Final
2022 Monitoring Report
Former Communications Site, Operable Unit 6
U.S. Army Garrison Alaska

HQAES No. 02871.1088
ADEC File No. 108.38.085
ADEC Hazard ID 4140

ALASKA DEPT. OF ENVIRONMENTAL CONSERVATION		DATE: 08/01/2023 REVIEWER: Timothy Sharp PHONE: (907) 451-2131	Action taken on comment by:			
Item No.	Drawing Sheet No., Spec. Para.	COMMENTS	REVIEW CONFERENCE A - comment accepted W - comment withdrawn (if neither, explain)	CONTRACTOR RESPONSE	ADEC/EPA RESPONSE ACCEPTANCE (A-AGREE) (D-DISAGREE)	CONTRACTOR RESPONSE
1	General Comment	Please update the Record of Decision (ROD) Remedial Goal (RG) for 1,2,3-trichloropropane (TCP) to 0.075 µg/L where applicable in the document, such as Table 1-2, Section 3.3, Graph 3-5, Table 3-3, Graph 4.2, etc. According to the Fifth Five-Year Review (2021), “Changes to a ROD ARAR have been promulgated since the Fourth Five-Year Review. Cleanup levels (CULs) in 18 AAC 75 are listed as an Applicable or Relevant and Appropriate Requirement (ARAR) in the OU6 ROD (USACE, 2014). In 2016, amendments to 18 AAC 75 updated calculation methods and values of CULs for soil and groundwater. Subsequent updates to the CULs occurred in 2018 and 2020. ROD proj

FIGURE:	3-2
---------	------------

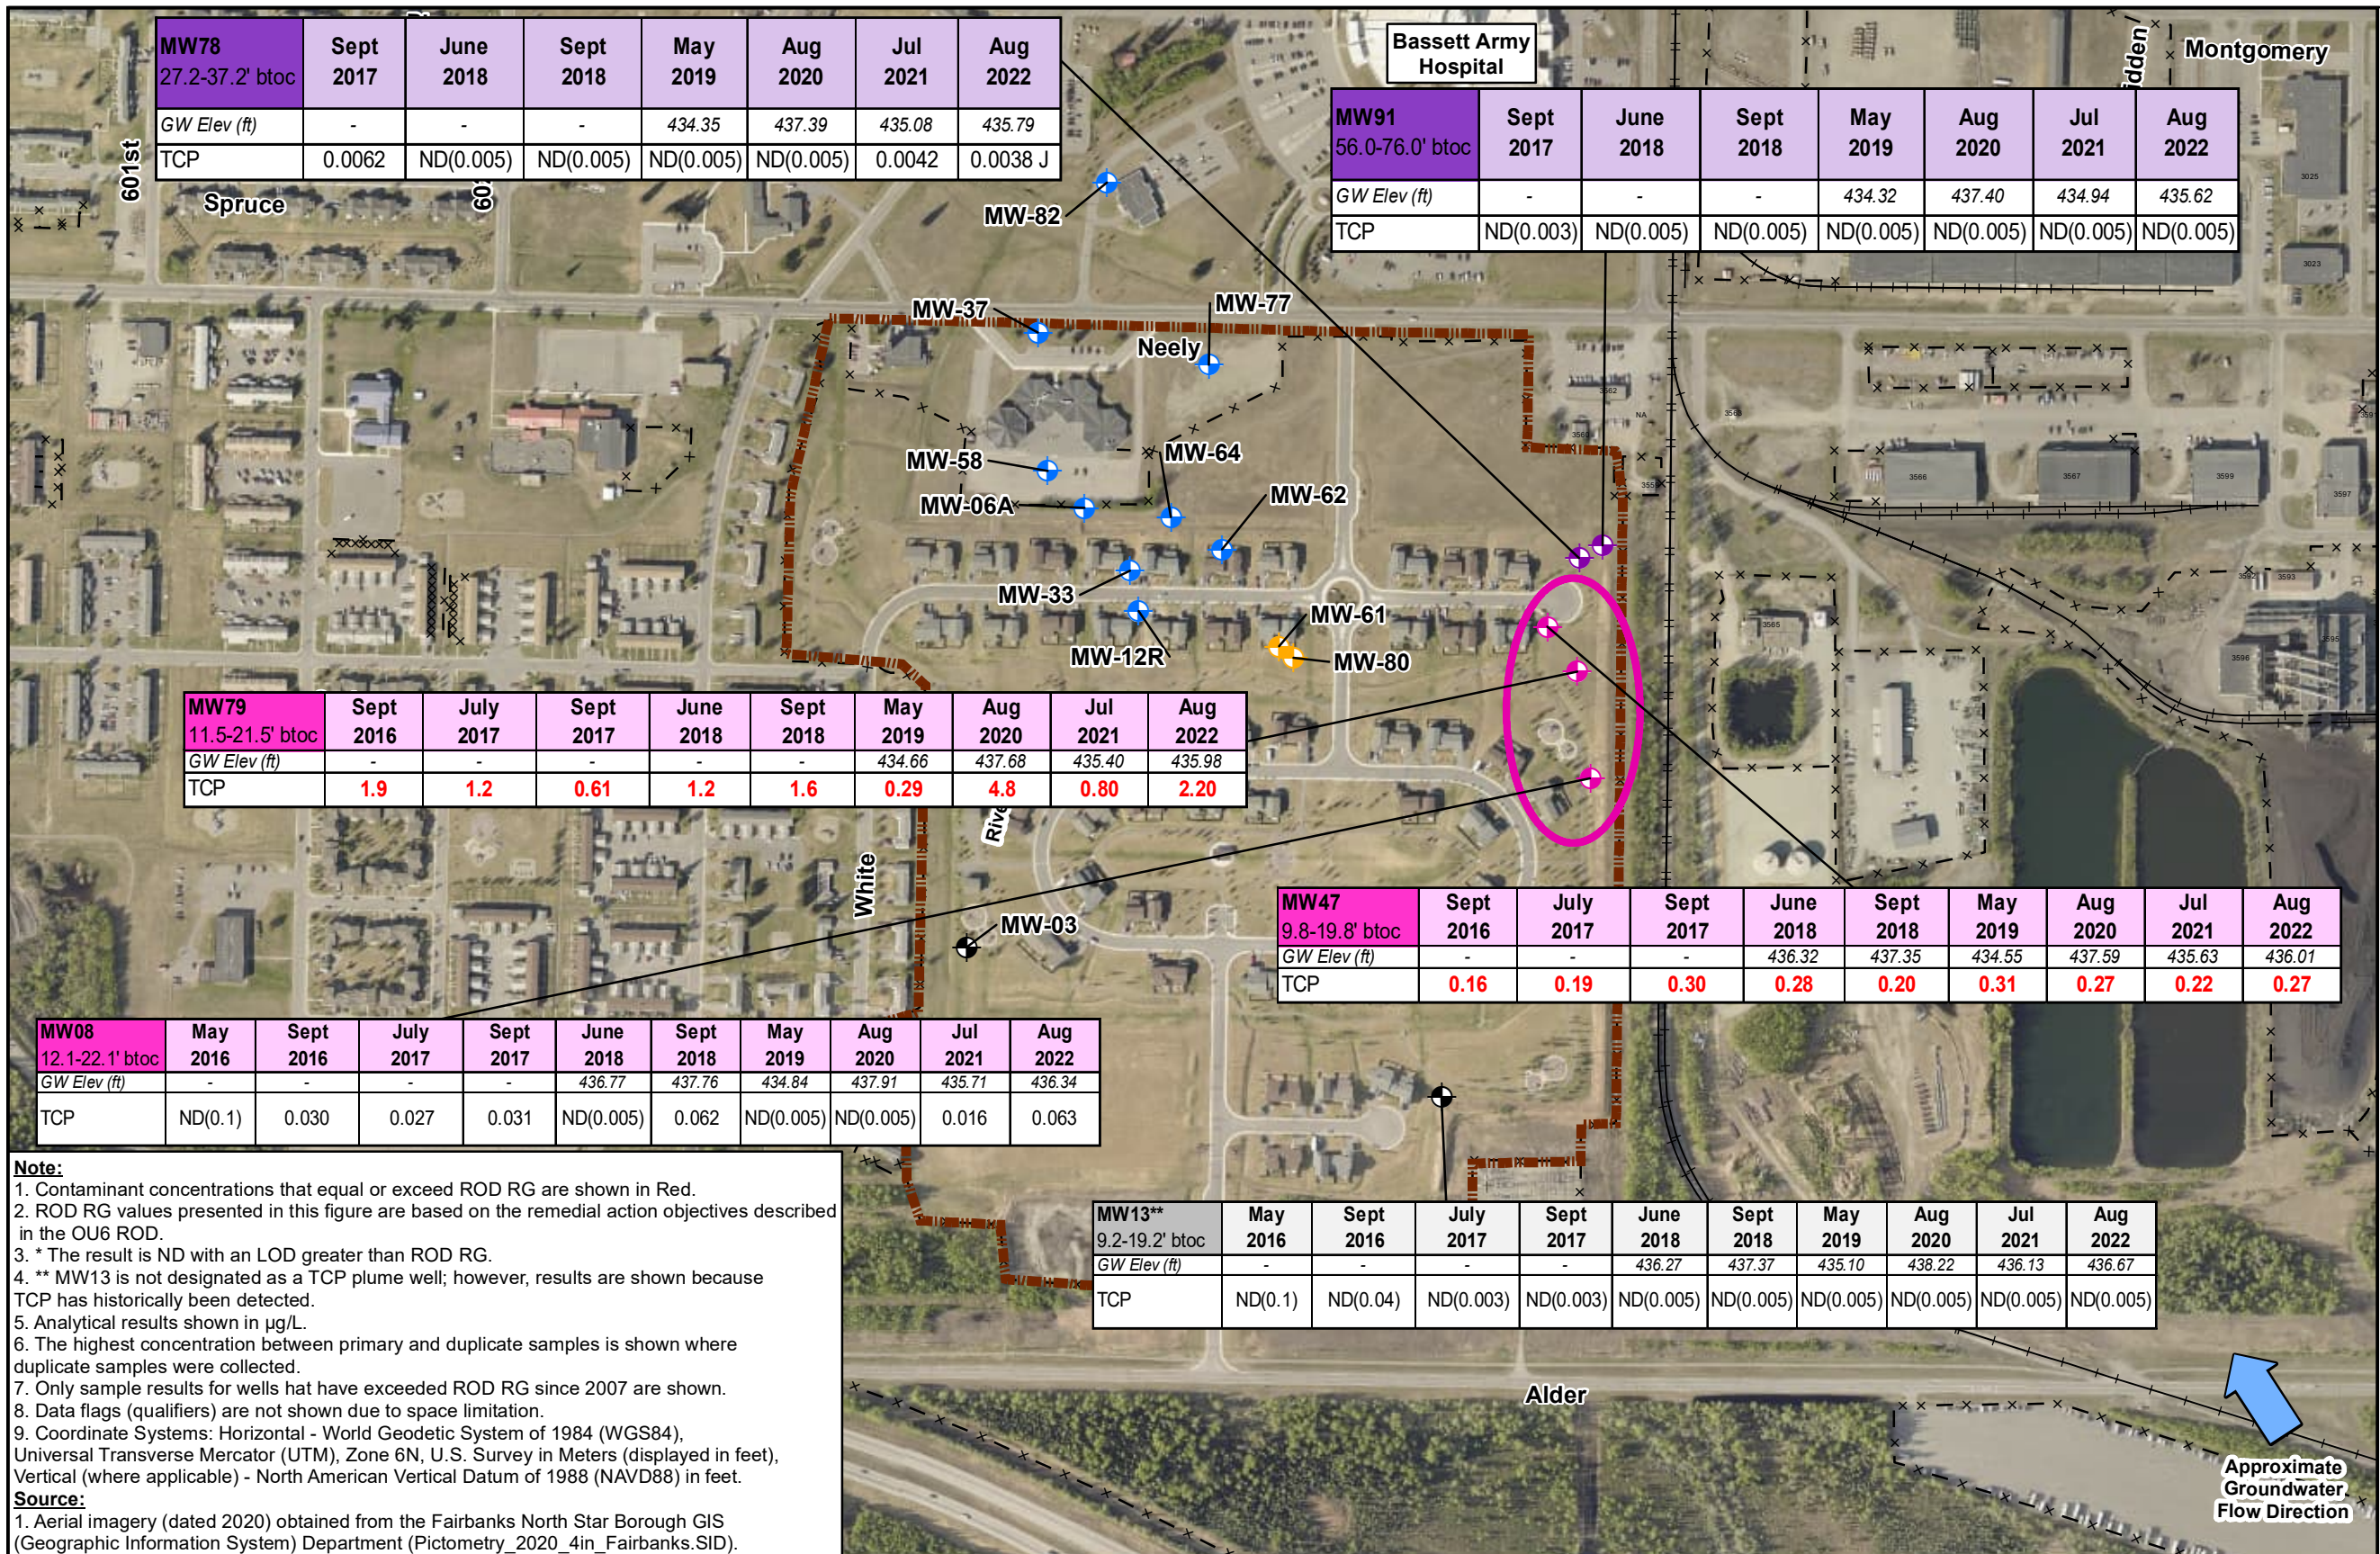
5.	54	Figure 3-2	Please remove the label for MW-35.	Accepted. The MW-35 label will be removed from Figure 3-2.	Accepted
6.	General		Has the TCP Source been removed? Or per the Exec Summary: “Exceedances will	There have been removal actions, but none have	Accepted
